## FTI-TLK1 Harness Bulletin - Mis-wired Power Circuits

## FTI-TLK1 Type 3C3 - Vehicle Coverage & Preparation Notes

Figure 1: Step by step adapter correction

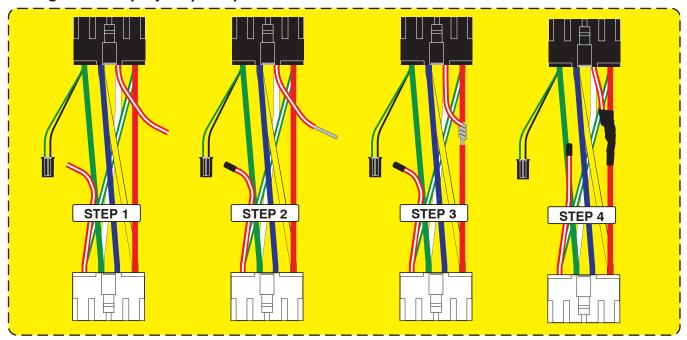
Overview: The initial production release of the FTI-TLK1 harness has an issue where in some vehicles the secondary power input to the CN1 connector will overload the associated vehicle circuit, causing a fuse to blow. This issue affects the initial release of harnesses and is already being addressed in production. A field correction procedure is detailed below in Figure 1.

Issue: The secondary power circuit can overload some vehicle ignition switch circuits, causing a blown 5A/7.5A AM1 fuse, potentially disabling the vehicle and leaving the consumer stranded. Affected adapters are illustrated below in figure 2.

- 1.) Select the applicable CN1 adapter, isolate the RED/WHITE power wire, cut wire approximately 4" from the BLACK plug
- 2.) Insulate the wire still connected to the WHITE plug using heat shrink tubing, and strip the insulation on the other wire end
- 3.) Strip a portion of the insulation from the RED wire, attach the stripped RED/WHITE to the exposed RED wire, solder together
- 4.) Apply insulating tape to the soldered connection and secure the cut ends back to the bundle of wires created by the adapter
- 5.) Correction complete, you may safely proceed to finish your installation
